Flight Procedures Cover Page	Task Action: FLIGHT CHECK	Task Type: IAP	Estimated Chart Date: 04/22/2021	APWS Task ID: 4C417DA45BEC4A4D91F1077972F291C5	APWS Project ID: 607D9941D78C42938D874C0F35378017
Procedure: ILS PRM RWY 9R (SIMULTANEOUS CLOSE PARALLEL) AMDT 3		Enroute: NO	Specialist: Vega, Ana		Agreement Number:
Airport ID: KATL			Airport City: ATLANTA		State: GA
Facility ID: FUN	Facility Type: ILS	Flight Inspection Remark Type: New FC Slot			
<div>Procedure Comments: ELIMINATE ALL USE OF ATL AND PDK FOR VORMON REQUIREMENTS. CONTACT: JOHN BORDY 405-954-0980</div> <div>QUALITY 25 CHECKED QUALITY 12 CHECKED</div>

FIPC BASIC FORM						
PROCEDURE: ILS PRM RWY 9R (CLOSE PARALLEL)AMDT 3			AIRPORT NAME: HARTSFIELD - JACKSON ATLANTA		AIRPORT ID: KATL	SPECIAL CONTROL NO: AP-01-206-21
FAC ID: FUN		CITY: ATLANTA			ST: GA	ORIG CHART DATE: 04/22/2021
DFL TYPE: PROC/A	THIRD PARTY: <input type="checkbox"/> YES	EST. TIME ON SITE: 0.4	REIMB. NUMBER:	PTS TASK ID:		
PREFLIGHT NOTES						
REVIEWER:					DATE:	
COMMENTS:					CHECK ONE: <input type="checkbox"/> FLT CK REQ <input type="checkbox"/> NFCR <input type="checkbox"/> REJECT	
						YES
					CPV COMPLETE?	X
PROCEDURE RESULTS						
INSPECTION D

AIRPORT ID:	KATL
AIRPORT NAME:	HARTSFIELD-JACKSON ATLANTA INTL
CITY:	ATLANTA
STATE:	GA
Proc ID:	ILS PRM RWY 9R (SCP)
Amdt #:	3
Scale:	1" = 500,000
MA HOLDING

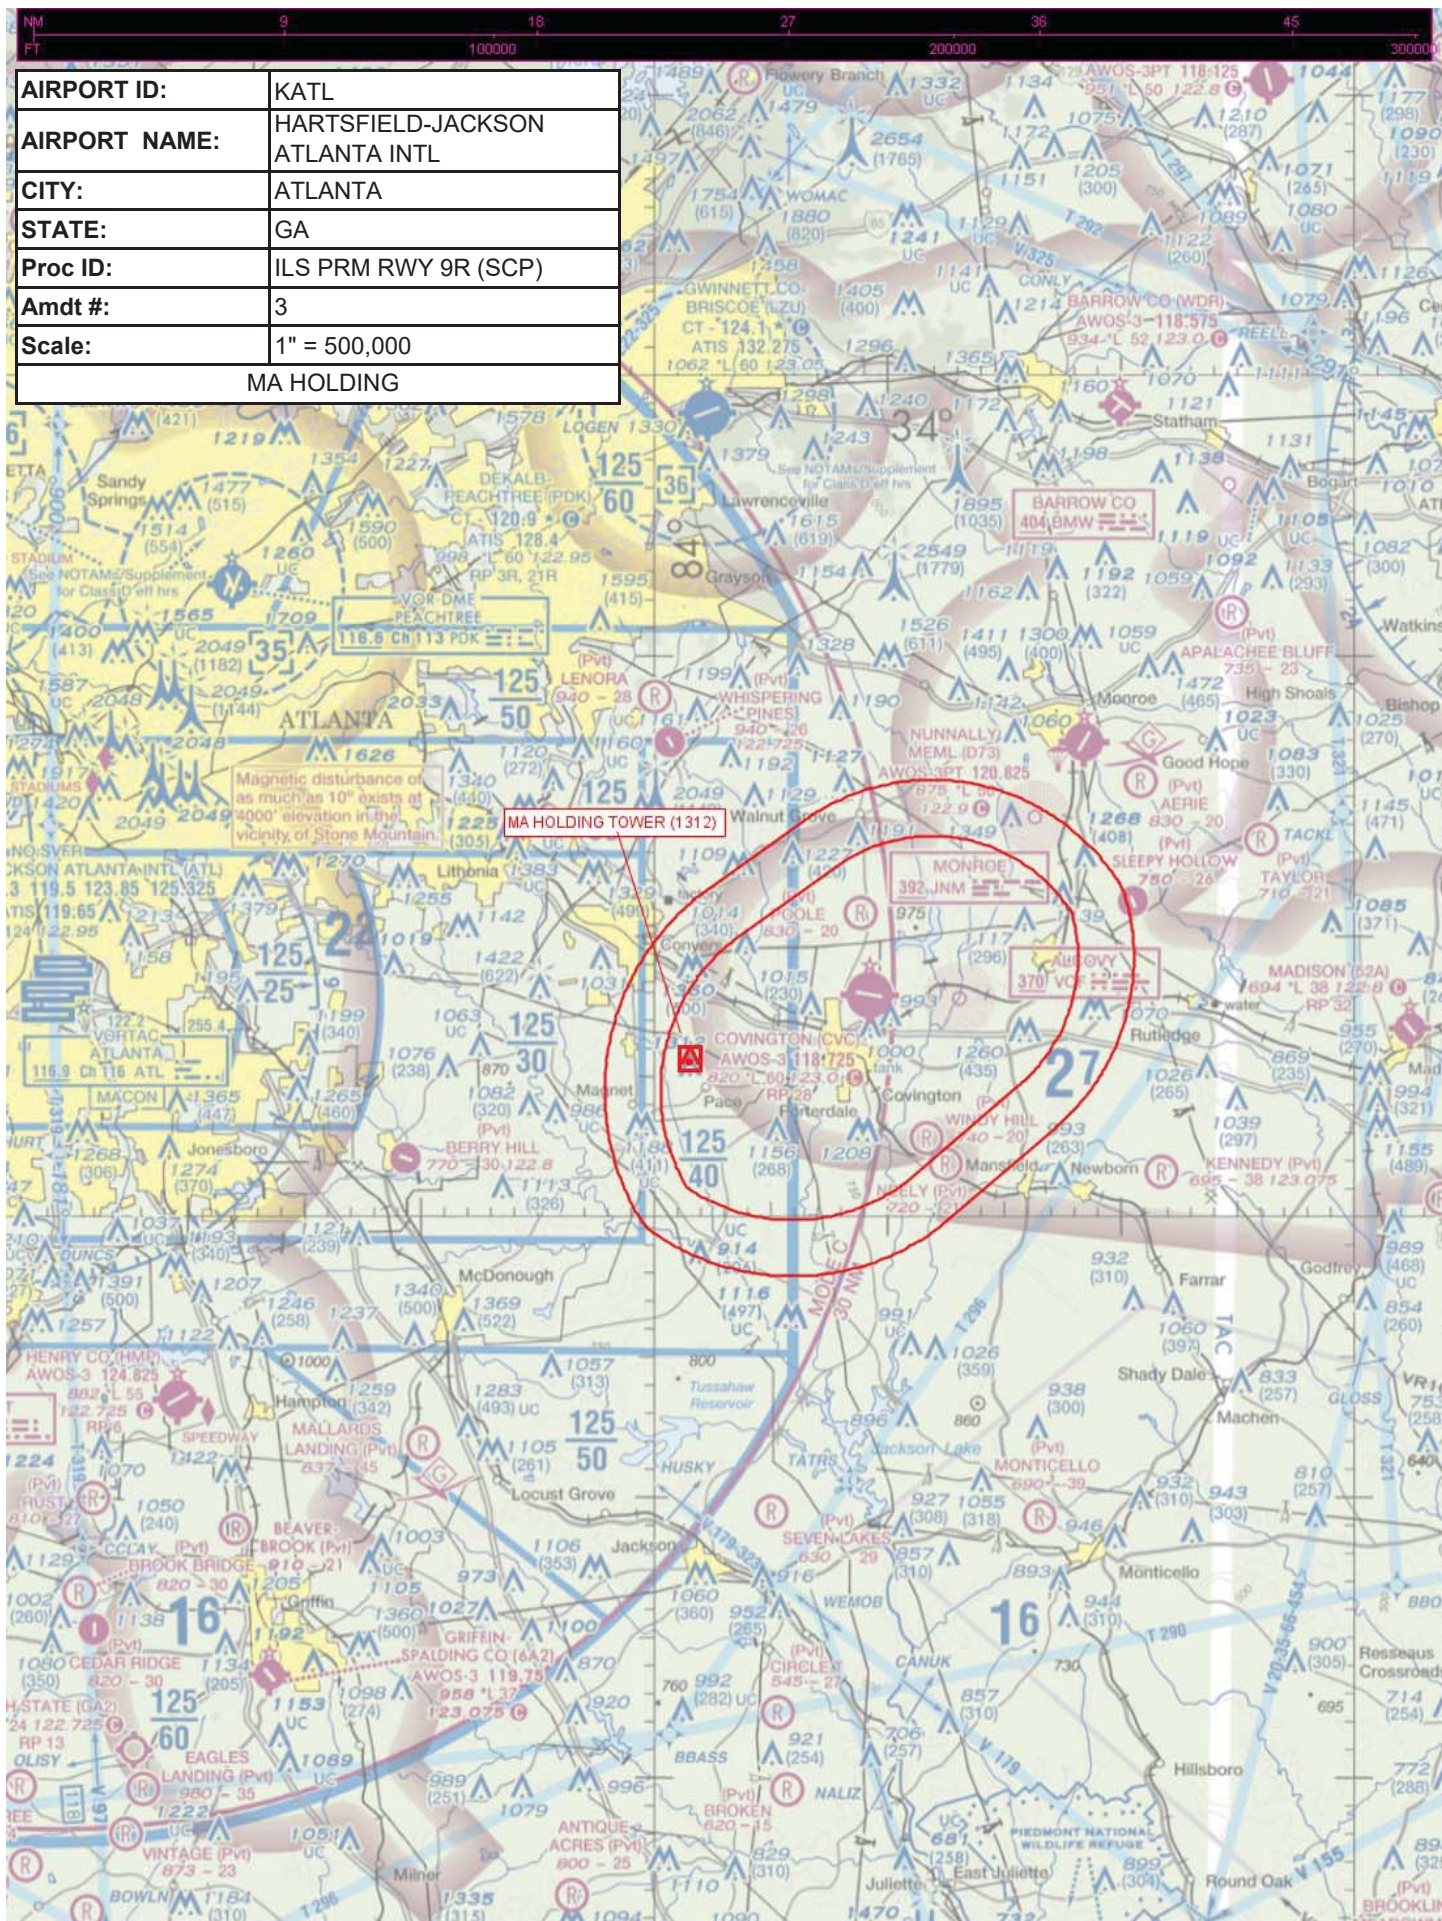
FLIGHT INSPECTOR REMARKS: CONNI intersection for missed approach holding point requires MRA changed from 3000 to 4000						
IN-FLIGHT OBSTACLE REPORT						
OBSTRUCTION ID #:	COORDINATES OR LOCATION:	GNSS ALTITUDE (MSL):	BAROMETRIC ALTITUDE (MSL):	HEIGHT ABOVE GROUND LEVEL:
